**DOCKET ITEM #8**  
**Master Plan Amendment #2020-00009**  
**Text Amendment #2021-00002**  
**Rezoning #2021-00003**  
**CDD Concept Plan #2020-00007**  
**Landmark Neighborhood – 5701, 5701B, 5801, 5815, 5901 Duke Street**

Application	General Data	
<b>Project Name:</b> Landmark Neighborhood CDD	PC Hearing	June 24, 2021
	CC Hearing	July 6, 2021
	If approved, CDD Expiration	July 6, 2051 (30 years)
	Plan Acreage	2,241,885 sq. ft. (51.5 acres)
<b>Address:</b> 5701, 5701B, 5801, 5815, 5901 Duke Street	Existing Zones	CR/Commercial Regional CRMU-M/Commercial Residential Mixed Use (Medium)
	Proposed Zone	CDD #29 / Coordinated Development District #29
	Proposed Uses	Hospital, medical office, office, multi- family, townhouse, retail, restaurant
	Total Floor Area – <i>Max Residential</i>	5,565,000 sq. ft.
<b>Applicant:</b> Landmark Land Holdings, LLC c/o Foulger-Pratt, 12435 Park Potomac Ave, Potomac, MD 20854	Small Area Plan:	Landmark Van Dorn Corridor Plan

**Purpose of Application**

Figure 12: Open Space

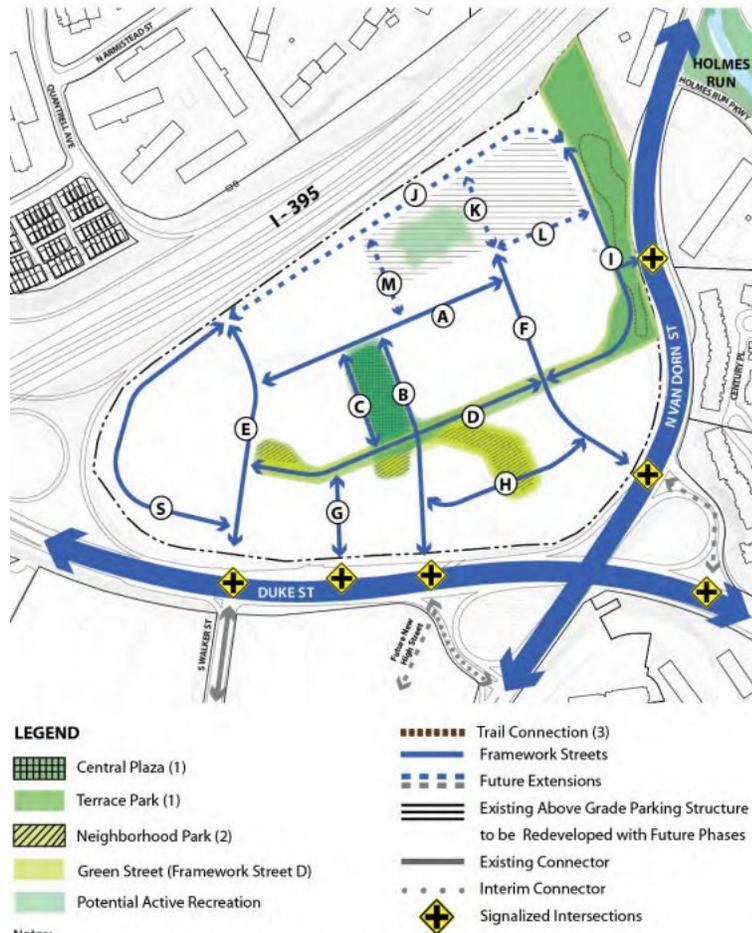
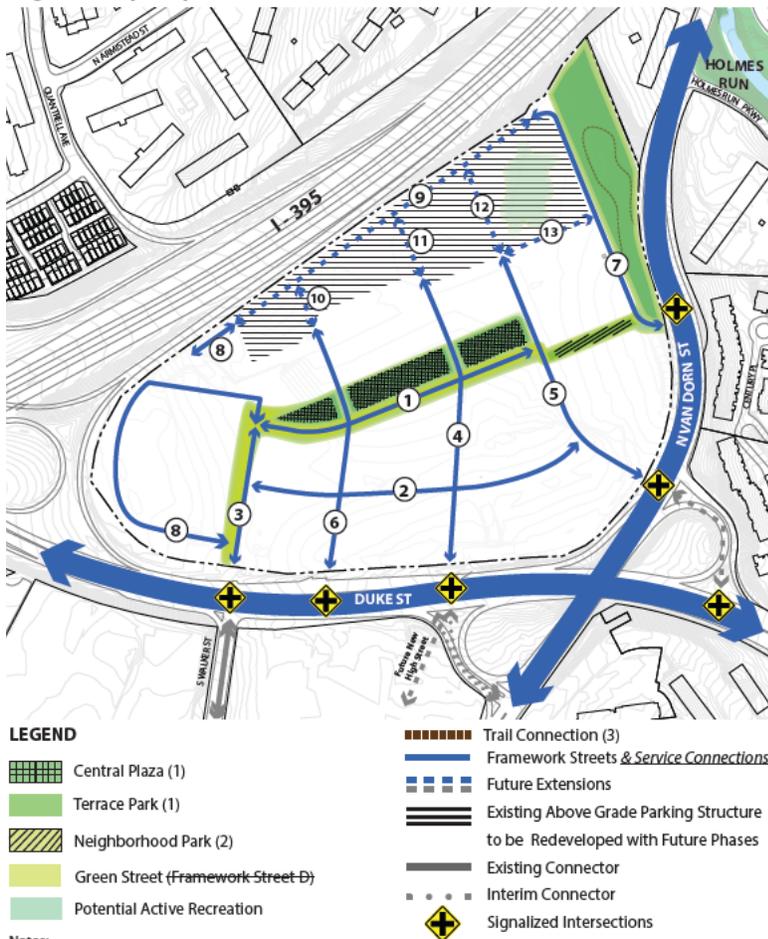
The Applicant proposes to amend the configuration of planned open space across the Landmark area, consistent with Sheet 12 of the CDD Plan. This revised location aligns with revised plans for the location of the “green street.” The location places the Central Plaza alongside a low-traffic road, and serves to connect the primary green spaces throughout the site, stretching from the Terrace Park and Paseo in the east, to planned open space on Hospital Campus in the west.

Figure 13: Land Use

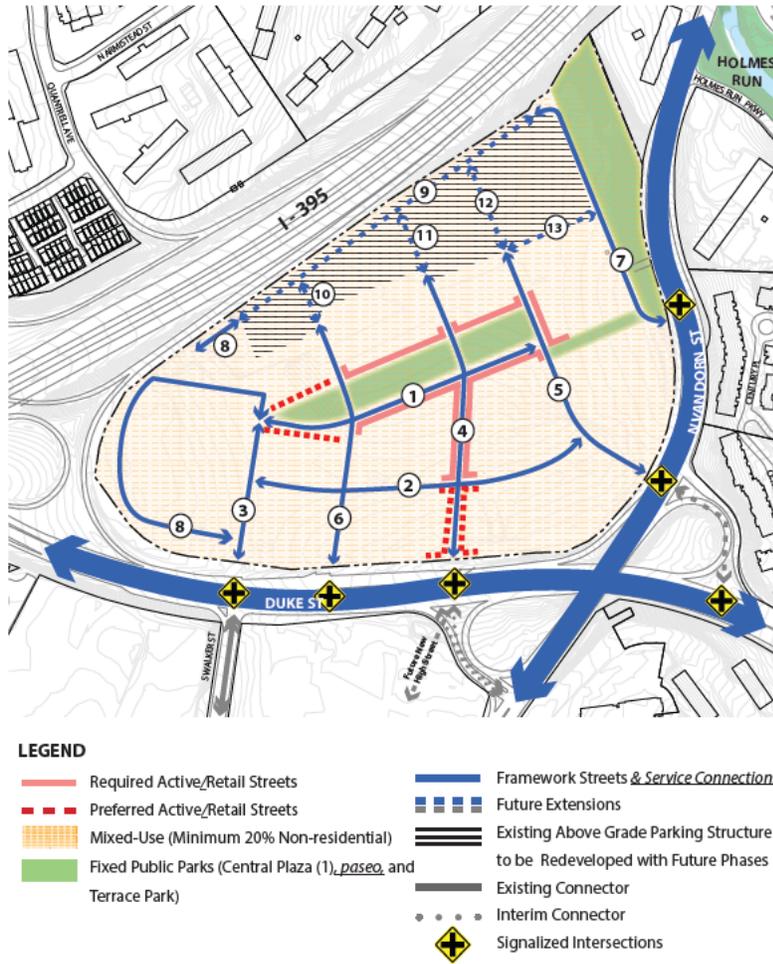
The Applicant requests an amendment to the location of required and preferred active retail on Figure 13 to align with the placement of “Primary Active Street Frontage” and “Secondary Active Street Frontage”, respectively, as shown on Sheet 03A of the CDD plan. Active street frontages have been located to take advantage of the location of the Transit Hub, the Central Plaza, and Road 1, concentrating retail to create the “activated retail core” described in the SAP. The legend for these items should also be updated consistent with the above.

Figure 15: Building Height

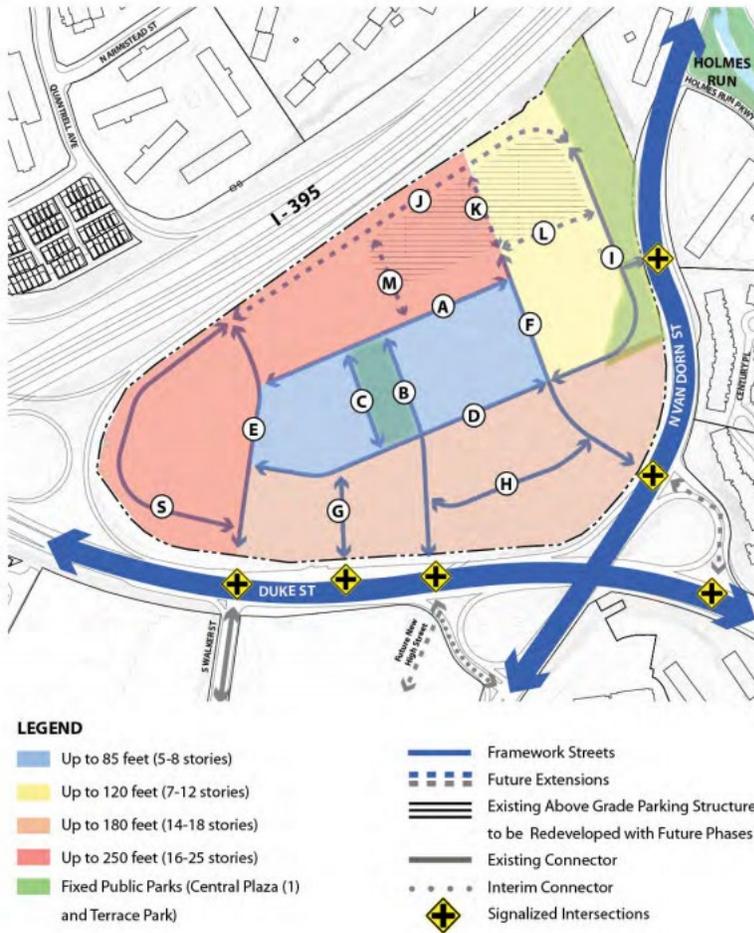
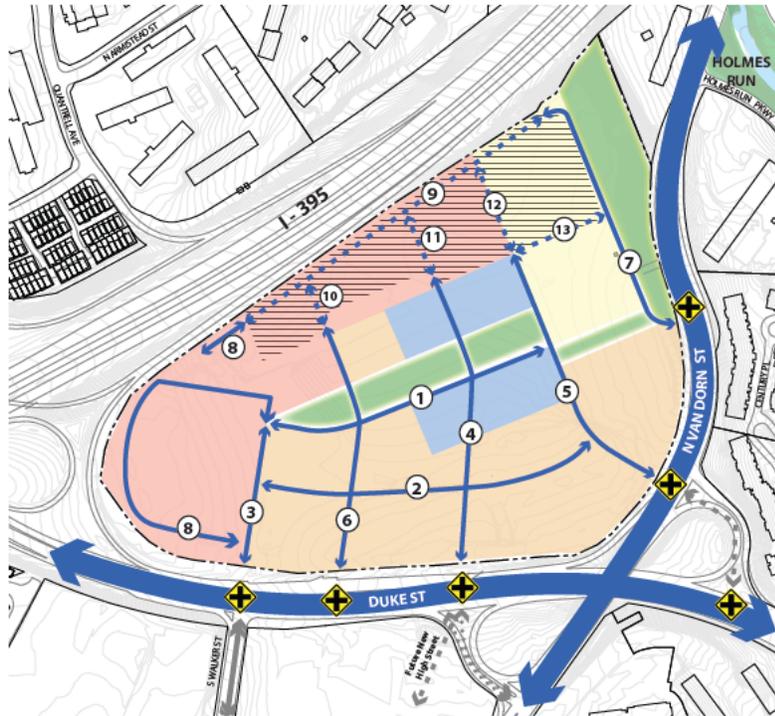
While the Applicant generally proposes lower building heights in the CDD plan, reflecting the overall decrease in density and changes in proposed construction type, the Applicant requests amendments to Figure 15 in the SAP to ensure that the maximum heights proposed on Sheet 13 of the CDD plan are permitted in the locations shown.

Figure 16: Building Streetwall, Gateway and Placemaking Opportunities

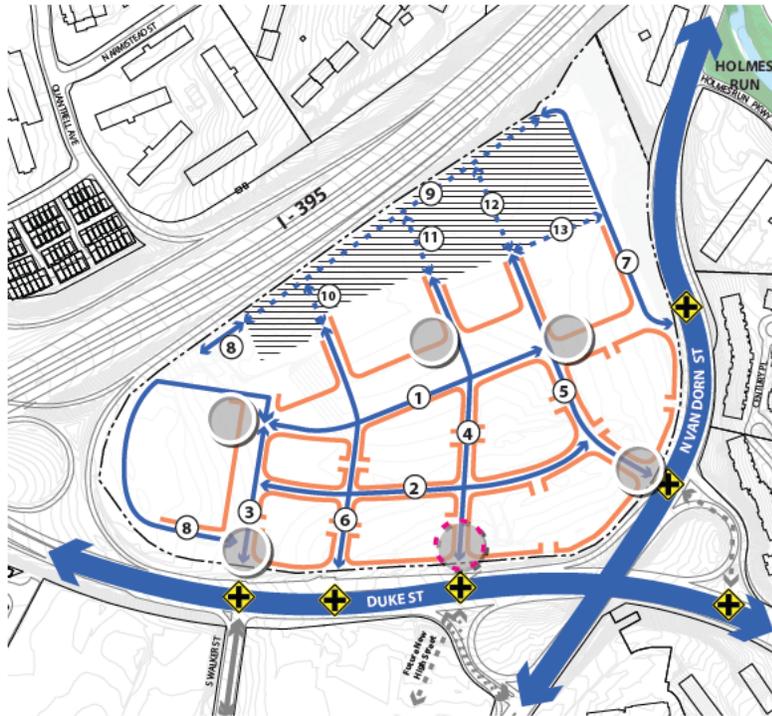
The Applicant requests an amendment to Figure 16 to reflect the revised locations for placemaking opportunities as shown on Sheet 13 of the CDD plan. This revision ensures that placemaking continues to be an option for those locations where it remains appropriate, aligning with other proposed changes to blocks and street locations, along with the location of active retail on the site.

Additionally, the Applicant requests the addition of a note that indicates breaks in the Streetwall as shown on Figure 16 are illustrative, and will be reviewed at the time of a DSUP.
